UNITED STATES PATENT AND TRADEMARK OFFICE

APPLICATION NO.	FILING DATE	FIRST NAMED INVENTOR	ATTORNEY DOCKET NO.	CONFIRMATION NO.
09/926,662	02/07/2002	Tatsuya Ariga	011405	5709

Office Action Summary

DETAILED ACTION

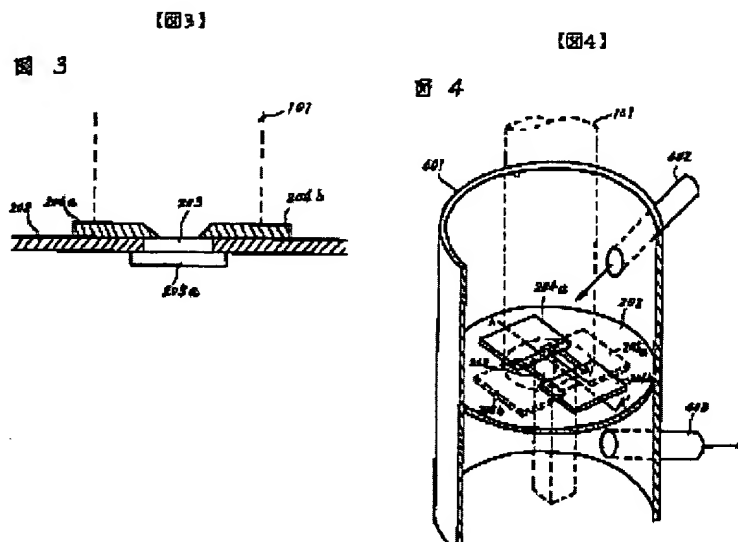
Claims 4 and 5 are rejected under 35 U.S.C. 102(b) as being anticipated by (JP 05-000390).

Figures 3 and 4 illustrate an aperture having a light transmitting section (203) surrounded by plates (204,205), made of copper, steel, brass or aluminum, for shaping a laser beam to a predetermined shape, where gas is blown into the vicinity of the aperture for cooling the aperture.

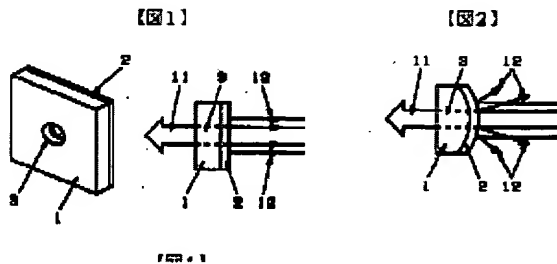
Claims 6,7 and 10 are rejected under 35 U.S.C. 102(b) as being anticipated by (JP 8-111551).

Figure 1 illustrates an aperture for shaping a laser beam to a predetermined shape having a shielding section made of multiplayer dielectric material, which will reflect the undesired beam portion away from the optical path as shown in figure 2.

In figure 1 Smith illustrates a laser system having an aperture with a light transmitting section and a light absorbing or reflecting section as disclosed in the abstract. As shown the reflected laser beam provides heating to the transmitting section.
